**INVITATION TO BID 2022-03
CITY OF PARKER
HIGHWAY 98 WATER MAIN DIRECTIONAL BORE
AT COOPER STREET**

**ADDENDUM NO. 1
REQUESTS FOR INFORMATION**

Issued May 12, 2022

Sheet No.
C1.1

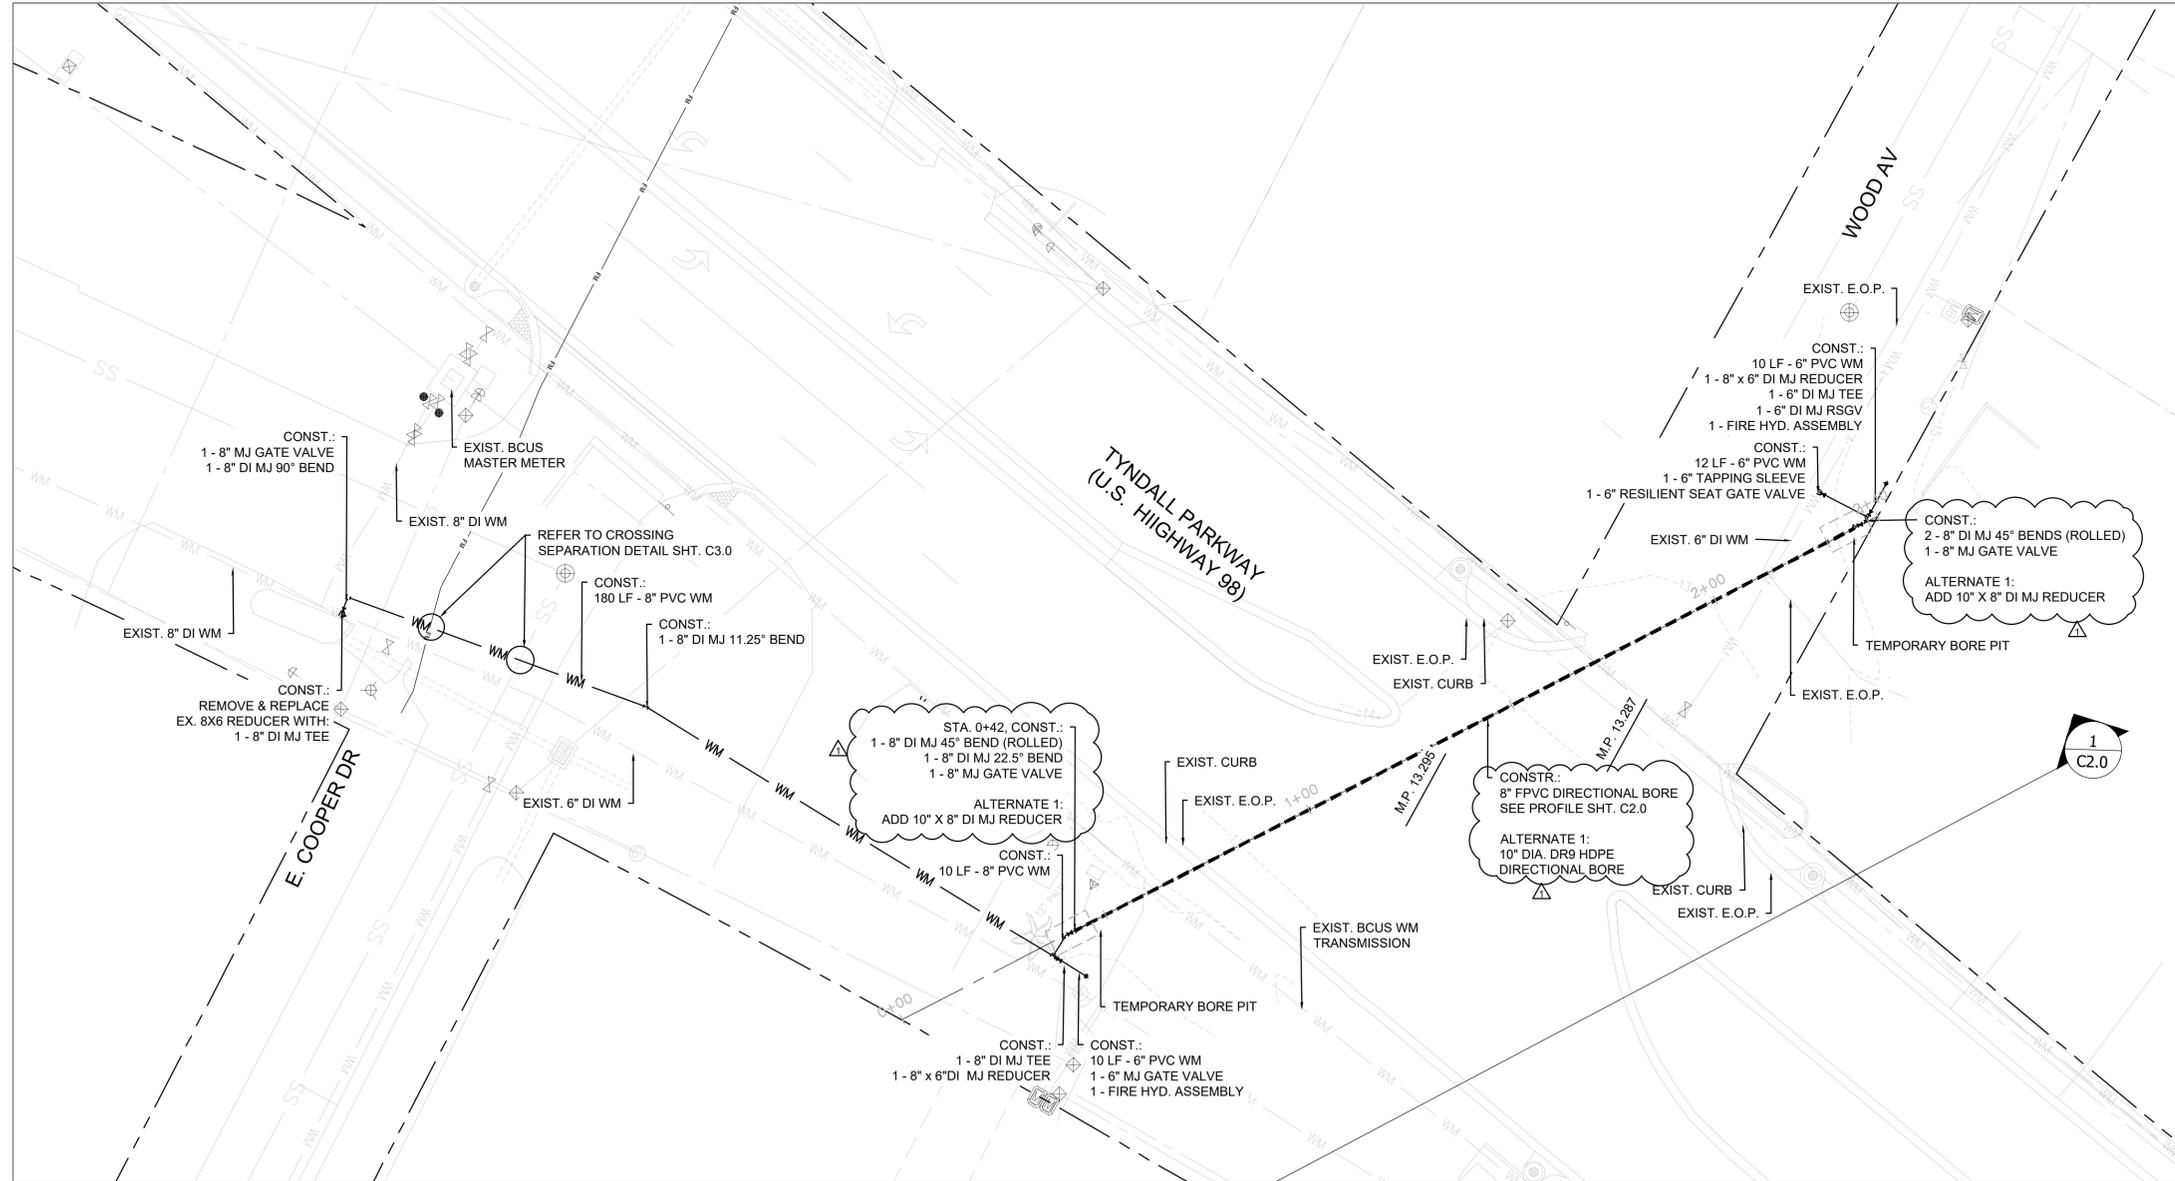
The City will allow for the use of a 10-inch HDPE pipe as an additive alternate to the 8-inch FPVC pipe. Please refer to Item No. 3 below for all documentation that is required to be removed and replaced or added for this specific modification.

REMOVE SHEETS C1.1 and C2.0 from the Bid Drawings and **REPLACE** with revised SHEETS C1.1 and C2.0.

1 COOPER ST - U.S. 98 DIRECTIONAL BORE SECTION
 SCALE: HOR. 1:20 / VER. 1:2

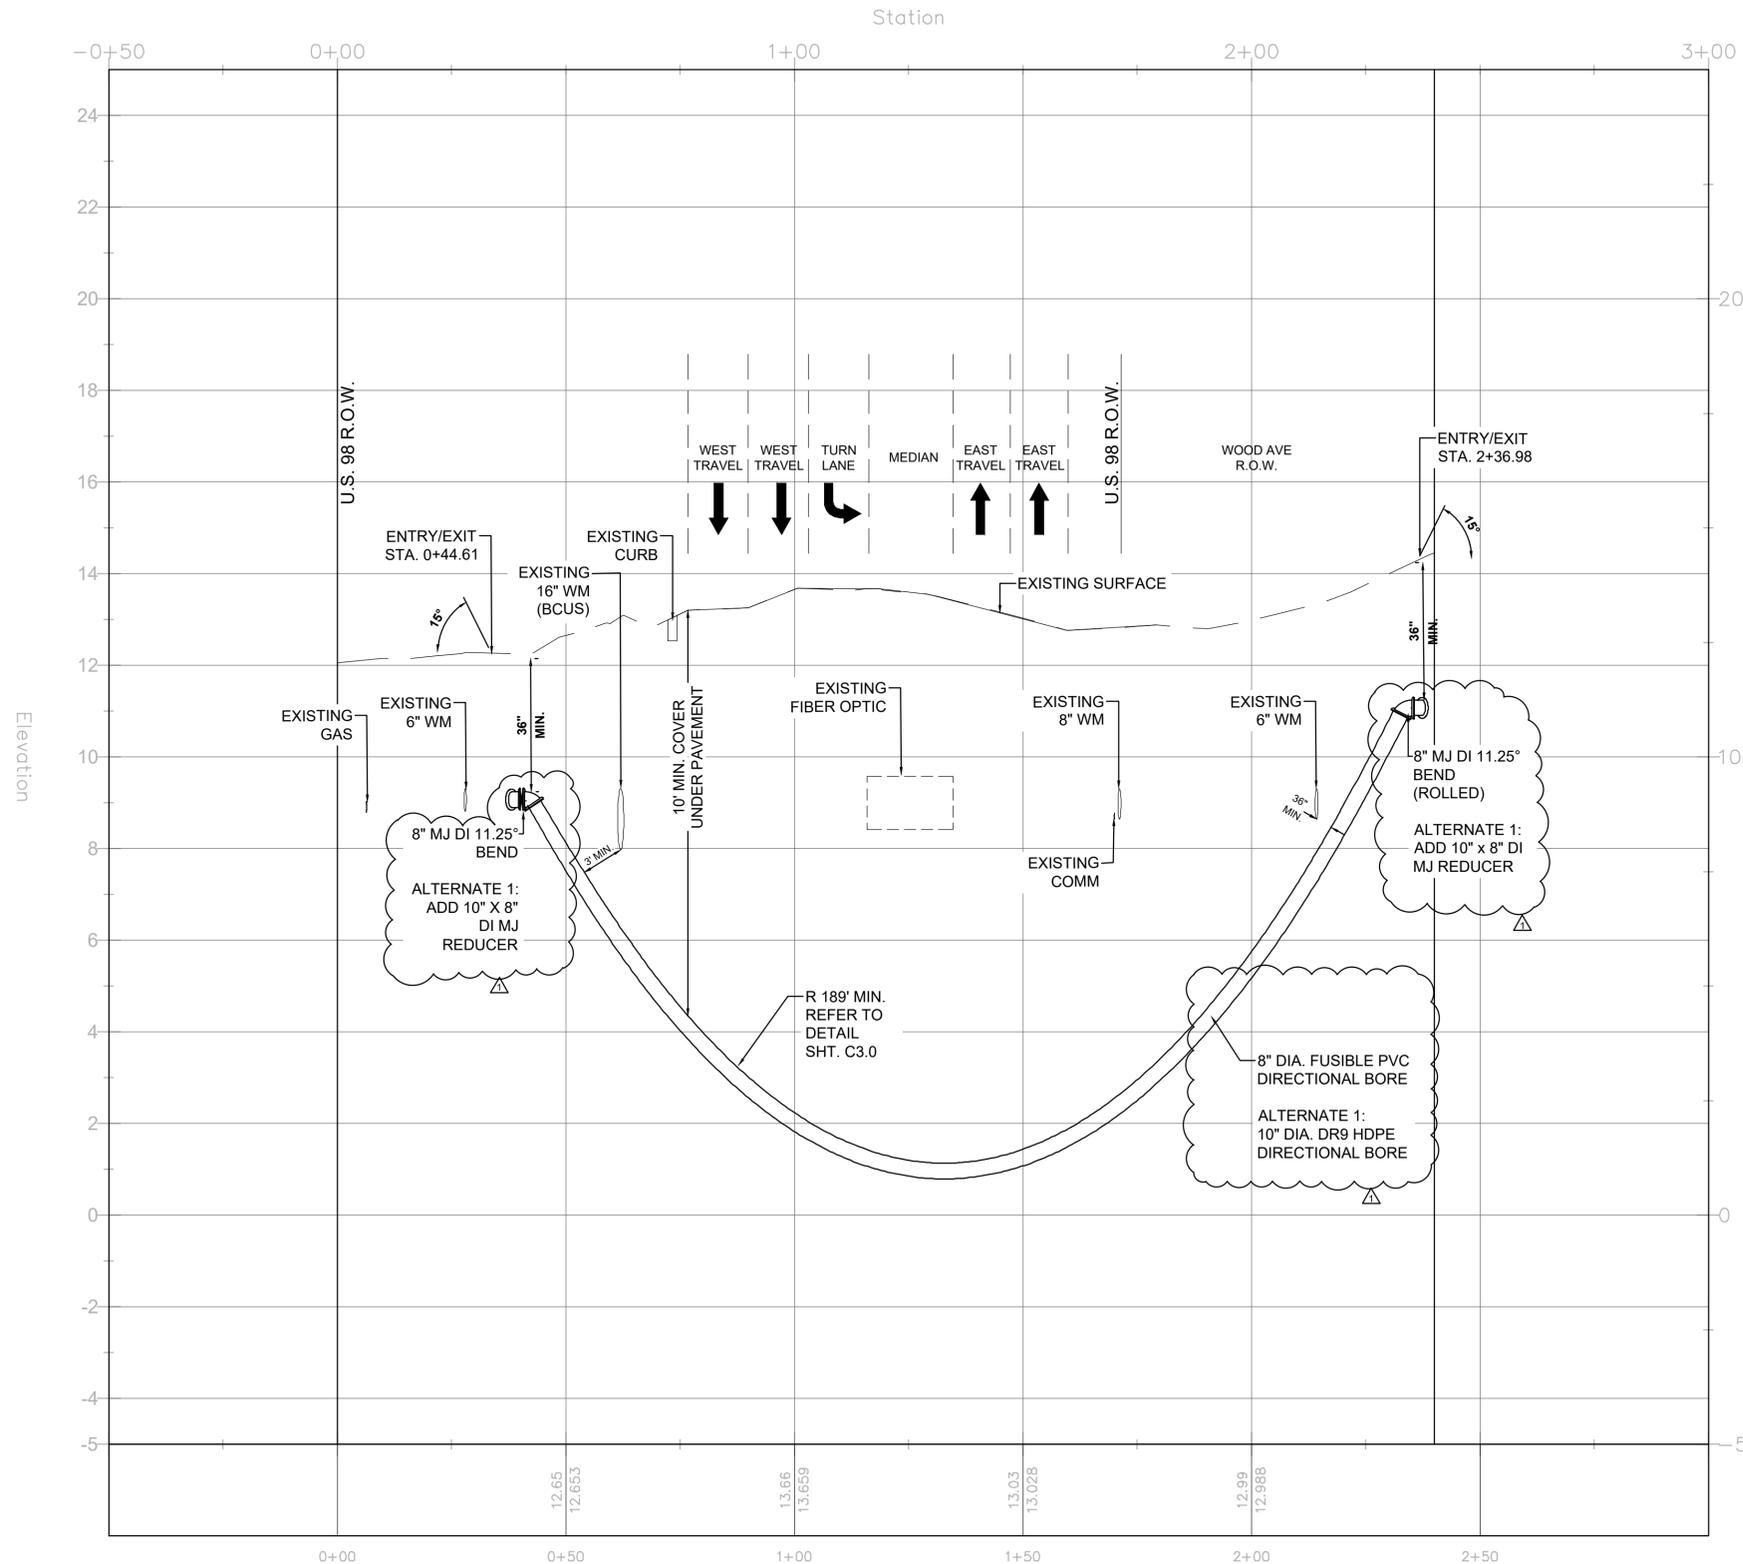
No.	Date	Revision
1	05/11/22	ADDENDUM 1
